VIRGINIA ELECTRIC AND POWER COMPANY
SURRY POWER STATION UNITS 1 AND 2
PROPOSED TECHNICAL SPECIFICATIONS CHANGE
TEMPORARY 45-DAY AND 14-DAY ALLOWED OUTAGE TIMES TO REPLACE
MAIN CONTROL ROOM AND EMERGENCY SWITCHGEAR ROOM
AIR CONDITIONING SYSTEM CHILLED WATER PIPING
RESPONSE TO REQUEST FOR ADDITIONAL INFORMATION

**Proposed Technical Specifications Change -
Temporary 45-day and 14-day AOTs to Replace
MCR and ESGR Air Conditioning System Chilled Water Piping**

Response to May 31, 2007 NRC Request for Additional Information

Response to June 5, 2007 NRC Request for Additional Information

Surry Power Station Area Map

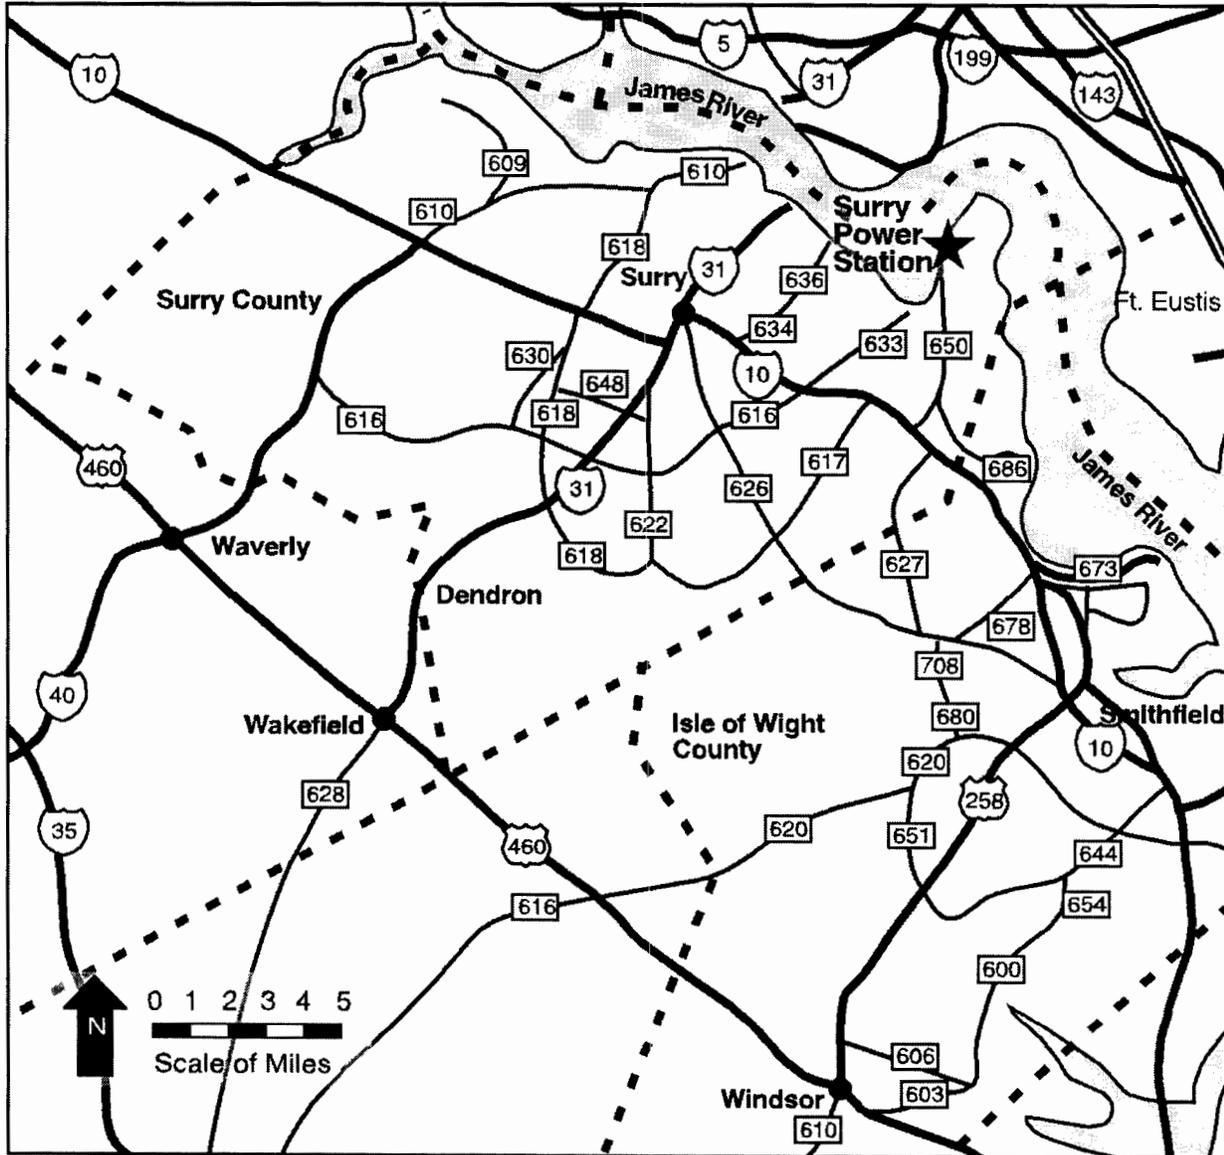
- 2. Page 5 of the attachment to your letter dated April 5, 2007, notes that measures would be taken if a tornado watch or warning has been declared for Surry County. What length of time would be required to suspend activities to a safe level once NOAA issued either of these declarations? In particular, page 6 of the attachment states that actions would be taken upon declaration of a tornado warning for Surry County. The Nuclear Regulatory Commission staff notes that issuance of a tornado warning means that a tornado has been sighted or indicated by weather radar. Therefore, please provide justification that adequate time remains to suspend activities to a safe level if it is likely that one or more tornadoes have already formed in the general site area. How large is Surry County and where is the Surry Power Station located within the county? That is, given that severe weather conditions may cover a large area, may move quickly, and that predicting with complete assurance when and where tornadoes will develop and move within the severe storm area is not realistic, please justify that basing decisions to take action on a declaration for Surry County is sufficient.*

As indicated in our April 5, 2007 letter (Serial No. 07-0109A), in this geographical area, tornadoes are typically associated with major weather fronts with severe thunderstorms. Thus, there would be advance notice of impending severe weather. The attached map shows the location of Surry Power Station within Surry County.
